UNITED STATES PATENT AND TRADEMARK OFFICE

10/754,546

Office Action Summary

Attachment for 10/754,546 <Final Rejection - Paper No. 20051019>

- Front View of Amorphous Semiconductor during Laser Crystallization

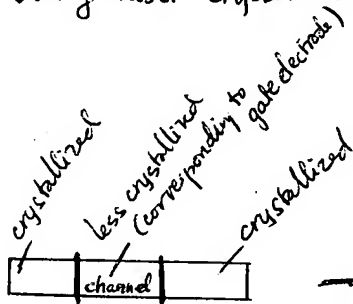
Examiner's response: Conventionally, when forming channels (for thin film transistors) from the amorphous semiconductor layer, the gate electrode was usually used as a mask. Therefore, after laser crystallization, the amorphous semiconductor layer became polycrystalline semiconductor layer with regions of crystallized and region of less crystallized. The heterogeneous straight lines were at the boundary of the regions of crystallized and region of less crystallized, [see figures from attachment provided by Examiner in this Office Action]. The figures that Examiner cited from Ohtani reference (from previous Office Action) were the evidence of forming the channel (for thin film transistor) from the amorphous semiconductor layer, and the heterogeneous straight lines inherently formed after laser crystallization.

laser crystallization

→ the lines at the boundary of the regions of crystallized & region of less crystallized are heterogenous straight lines.
